**M4R PROJECT – CONSULTANCY FOR ELEMENT MATERIALS
TECHNOLOGY: SUMMARY OF CONSULTATION REGARDING
IMPLEMENTATION OF MEASUREMENT METHODS
CEN/TS 17337:2019 AND PREN 16429 FOR THE MONITORING OF
POLLUTANTS FROM INDUSTRIAL PROCESSES REGULATED
UNDER THE INDUSTRIAL EMISSIONS DIRECTIVE**

FEBRUARY 2021

This report provides a transcript of a Q & A consultation carried out for Element Materials Technology under the Measurement4Recovery (M4R) programme. The Environment Agency for England with agreement from Element Materials Technology were also party to the consultation as a relevant stakeholder. The consultancy concerned the measurement of ‘reactive’ gases from industrial processes regulated under the Industrial Emissions Directive (2010/75/EU) in accordance with CEN/TS 17337:2019 ‘Stationary source emissions - Determination of mass concentration of multiple gaseous species - Fourier transform infrared spectroscopy’ and prEN 16429 ‘Stationary source emissions — Reference method for the determination of the concentration of gaseous hydrogen chloride (HCl) in waste gases emitted by industrial installations into the atmosphere’ addressing various measurement issues. The consultancy was led by M

Figure 1: Real example of annual rise and fall response time testing switching between pure N₂ and ~16 mg.m⁻³ HCl/N₂ after dry passivation (with ~16 mg.m⁻³ HCl/N₂) of the measuring system.

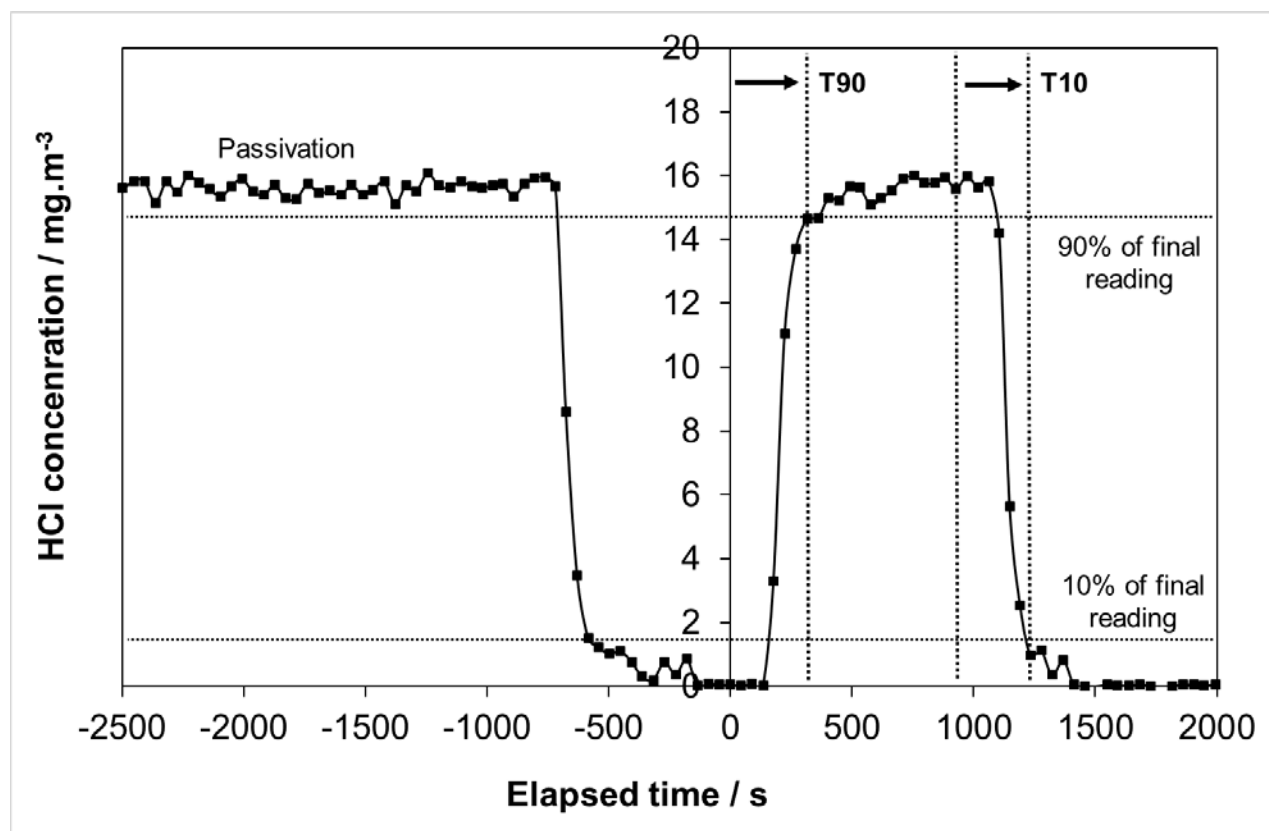
2.1.3 (Q3) the 400s for reactive gases proves a problem then I can see us reverting to extractive tests which would be more time and cost we would have to pass on

In terms of a practical 'work around' there are one or two options. With respect to a response time test in the field then after setting up the measurement system one option is to place the probe and sample stack gas to passivate the apparatus (15 min can be sufficient depending on flow rate). If the system has been allowed to fully passivate then the response time test requirement should be routinely met. Furthermore, from a QAL2 perspective it is the response time of a fully stack gas passivated P-AMS that is the parameter that needs to be known. i.e. the difference between the response time of an un-passivated P-AMS and a passivated AMS will not show to what degree one lags behind the other when both measuring stack gas over a 3-day period.

With respect to the annual response time test in the laboratory the above is generally not possible as there is no such source to sample from. However, dry passivation - although taking significantly longer to achieve than wet passivation - will then allow the response time test requirement to be met. An example is shown below of a real annual response time test using ~16 mg.m⁻³ of HCl. After a significant period of dry passivation of the measuring system the HCl/N₂ is switched out and pure N₂ switched in, once stable zero readings (<2% of range) are achieved the rise response time test is initiated and this achieves a time of <400s, as equally does the fall time test, hence, both serving

(along with other annual tests) to confirm the P-AMS system is in normal working order post manufacturer annual servicing.
